EXHIBIT FOR REZONING MABRY ROAD
FOR
LOT ONE HOMES
LOCATED IN
LAND LOT 32
1ST DISTRICT, 2ND SECTION
COBB COUNTY, GEORGIA

PETITION NO: Z-48

ZONING COMMENTS:

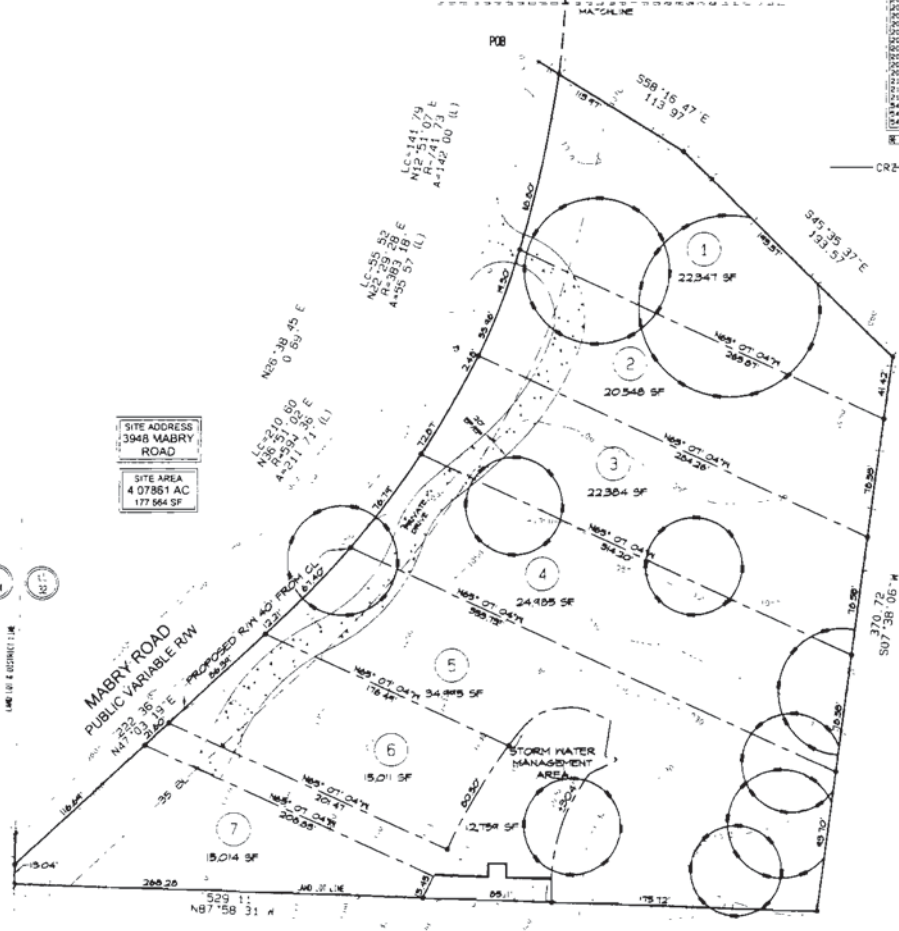
- No Stormwater controls shown _____
- Copy of survey is not current – Additional comments may be forthcoming when current site conditions are exposed.
- No site improvements showing on exhibit.

2. The proposed plan indicates that a poured-in-place wall will be utilized for the required detention pond. Due to its location adjacent to existing downstream properties, the wall should be decoratively faced and well-screened from the adjacent parcels to the south. The drainage easement for this pond will need to extend a minimum of 12 feet from the 100-year flood pool boundary to allow for adequate maintenance.
